RE: [EXTERNAL] :Re: Cecils Kersey Farm Doc 401125631

Is there any chance you could add 1 LACT unit to this 2A (401125631)? Attached is the revised facility layout showing the LACT location.

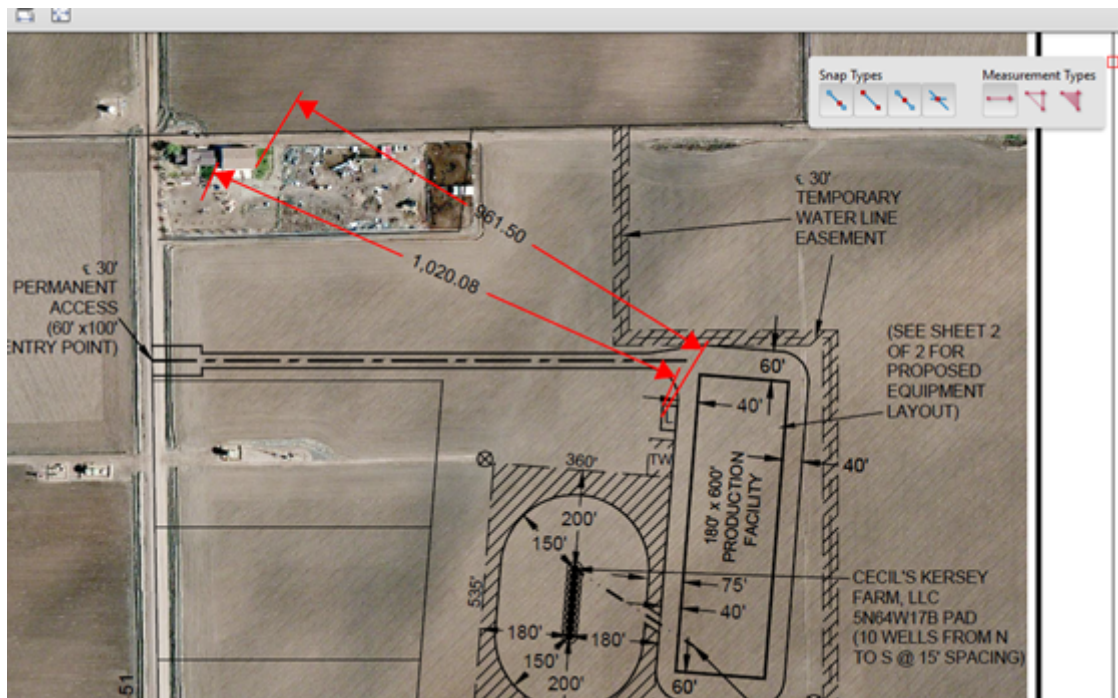
I will be happy to do this. I do see something that I need to get from you because of this. On the 2A, the nearest production facility to a Building Unit are the oil tanks to the Building Unit to the northwest at a distance of 1,066 feet. Where you have the LACT Unit placed, it now appears as if it is closer to both that Building Unit (1,020 feet) the adjacent Building (961 feet) than the oil tanks. I have attached a screenshot with some rough measurements. Will you give me updated distances to the nearest Building Unit and Building from the LACT Unit? Thanks.

BU = 1026'

Building = 965'
